Subject: TRIMMED: SUBMISSION - Queries/Concerns re DA 2025/0200

In reference to the DA 2025/0200 for 14 Kristine Place Mona Vale NSW, I have some queries and concerns pertaining to the application regarding visual privacy concerns, loss of views and loss of sunlight, compliance concerns, possible inaccurate reporting, existing garden impacts and window sill heights.

## **Views lost**

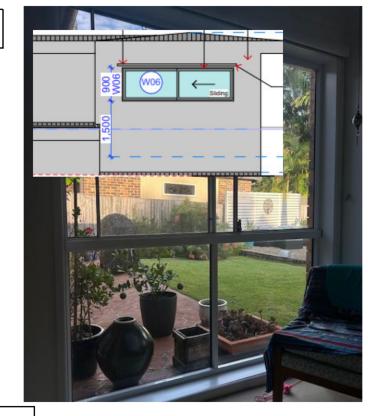
Please refer to attached images (Fig1, Fig 2, Fig 1.1, Fig 2.2) and also please note afternoon sunlight lost as highlighted on Master Plans Page 11. These issues are a significant concern.

Fig 1. Current view from main bedroom window.
Fig 2. Likely view post construction.
CONCERNS: lost views and privacy issue.

# **Views lost**

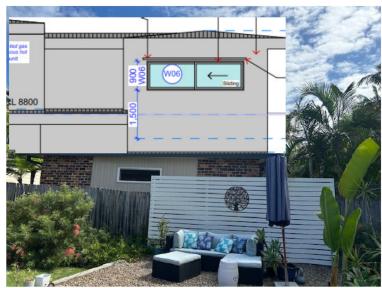
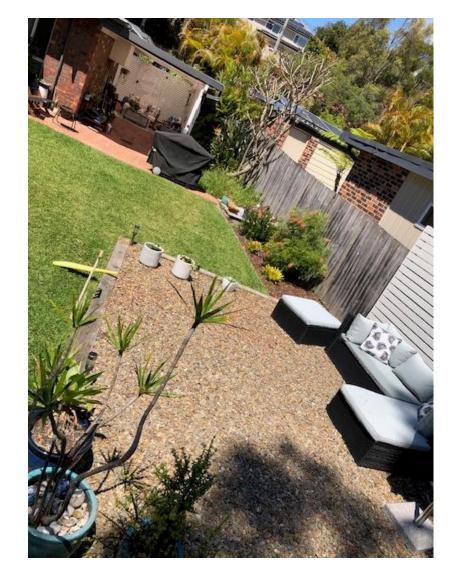
Fig 1.1 Current view from outdoor entertaining area. Fig 2. 2 Likely view post construction.
CONCERNS: lost views and privacy issue.
